VANDERBURGH COUNTY ENGINEERING DEPARTMENT

September 26, 2013

Based on an inspection that was completed on September 11, 2013 in Chadwick Place subdivision, the items that need to be addressed currently include the following:

The following documentation is hereby submitted by F.T. Kelley & Sons Incorporated on behalf of Steve and Penny Garrett of 15341 AJ Dr. located in lot 39 of the Chadwick subdivision for permission to relax the 35' drainage easement located in the homeowners' back yard in order to install an in-ground swimming pool.

EXHIBIT
C1

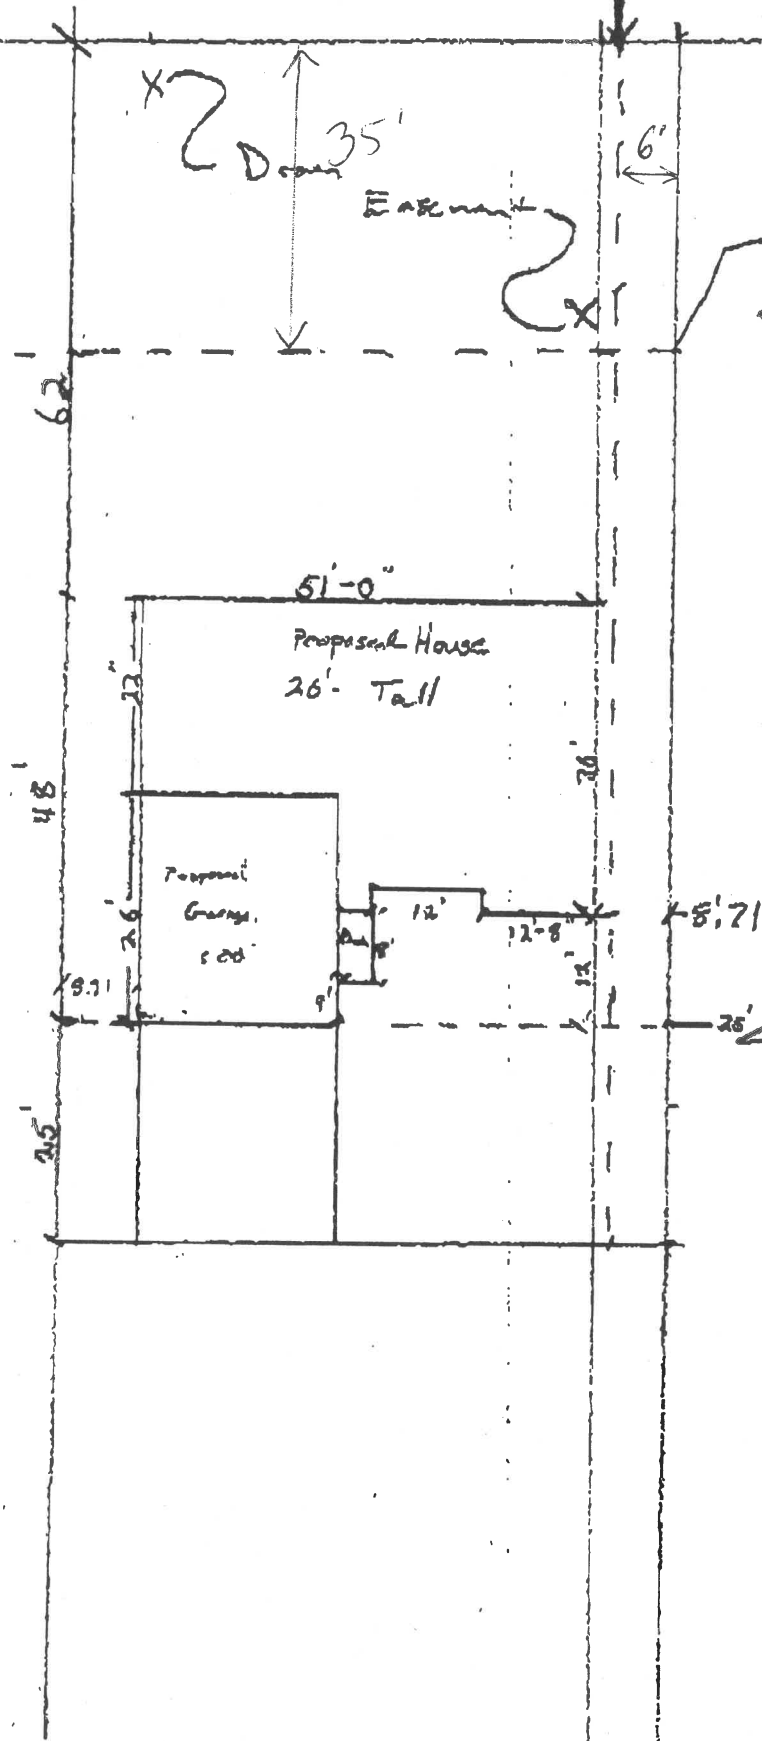
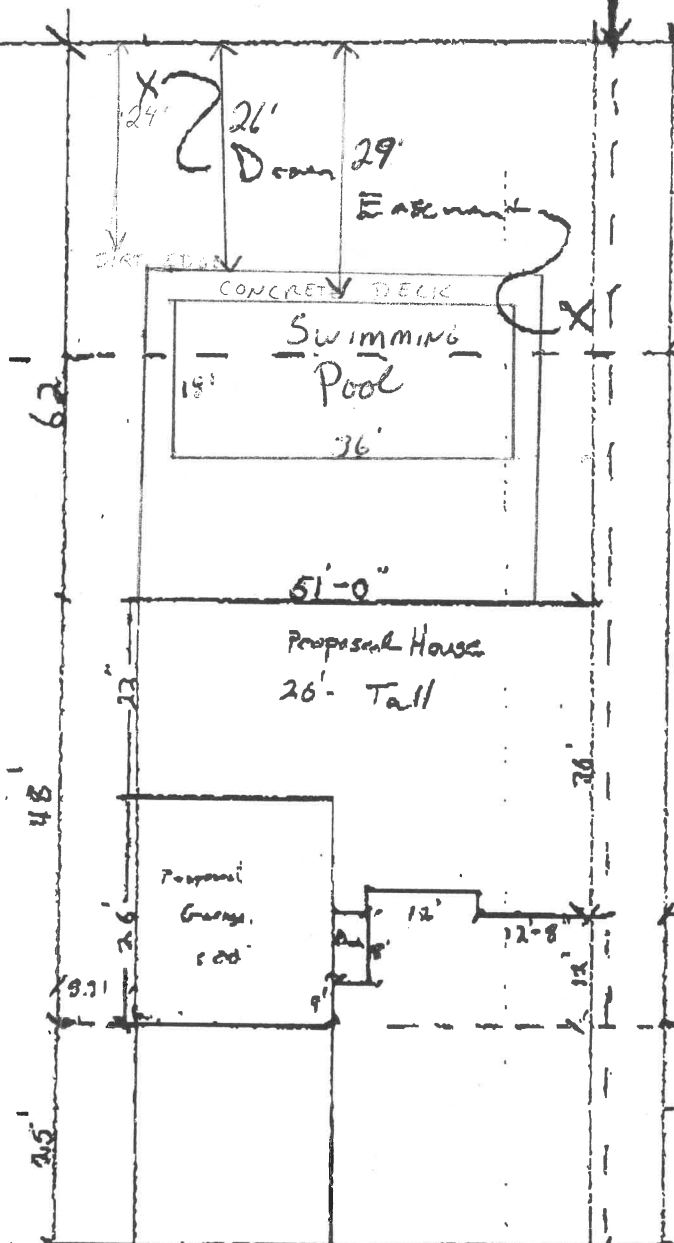
We are requesting a relaxation of the 35' drainage easement in order to construct an 18'x36' swimming pool in the back of the property. The pool will be centered with the house and extend 15' from the house to the east. The roughly 18" of fall to the yard over the 36' length of the pool will be kept at house level and then feathered and graded back into the easement with roughly 2' of fall over 2' extended from the concrete decking toward the east. A 4" corrugated perforated perimeter drain will encircle the pool and will terminate out into the easement. The exact location is to be determined at the time of construction on how the ground ultimately lays. However, it will extend no more than 3' from the edge of the concrete decking. This drain is not a backwash drain, and the only collection of water to pass through it will be from heavy rains or any welling of ground water around the structure.

In order to fit the pool in the yard to these specifications, we are asking for a relaxation of 11' of the 35' drainage easement for the construction of the structure with and understanding that we will be feathering a small retaining berm back from the concrete edge falling roughly 2' over 2' in order to dress up the structure and to not interfere with the function of the drainage easement.

TYPICAL DRAINAGE SWALE - LOT 10-26

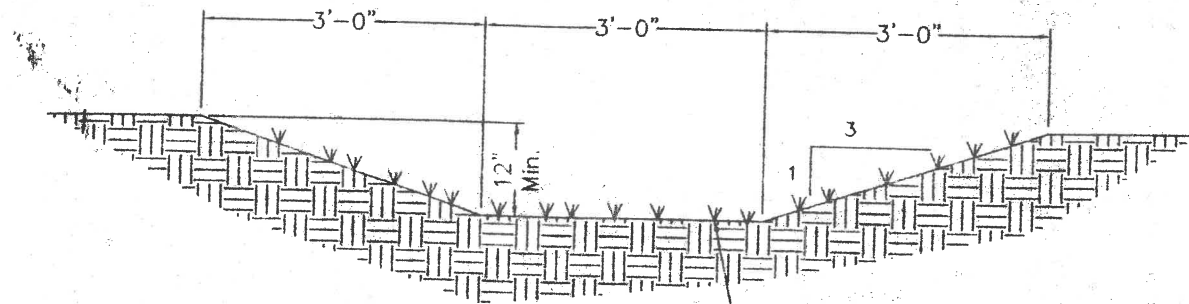
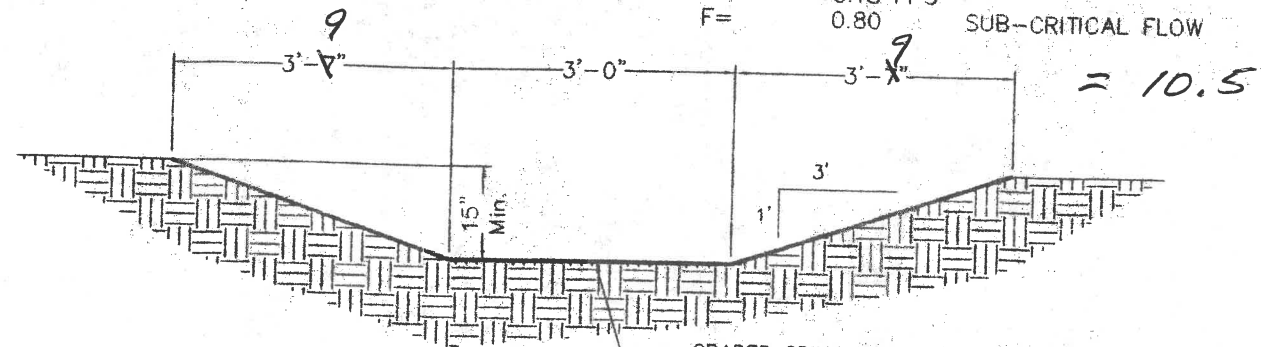
2. The drainage swale from lots #11 thru #26 was not constructed according to the approved drainage plans. The swale cross section does not match the requirements of the approved plans. There are several fences encroaching in the easement for this swale. There are also decorative bricks placed at the bottom of the fence at 15212 AJ Drive possibly to block the flow through their yard. Also since the swale was not built here it appears water may be forced into Poet Square instead of being contained inside the Chadwick Place easement as required by the approved drainage plans. The drainage easement is only 5' wide in Poet Square, so there is not sufficient easement width in that subdivision to accommodate moving the swale into Poet Square.

FROM PLANS - DITCH DESIGN 11.03 CFS

DITCH WILL CARRY FLOW AT 0.69 FEET

PLANS SHOW 15" MIN

CHANNEL 3' + 3'7" + 3'7"

(SHOULD BE 3'9") \Rightarrow 10.5'

4. The drainage swale from lots #11 thru #26 is not built according to the approved drainage plans. Also there are 2 fences encroaching in this swale located at 15144 & 15212 AJ Drive. There are decorative bricks placed at the bottom of the fence at 15212 AJ Drive possibly to block the flow through their yard.
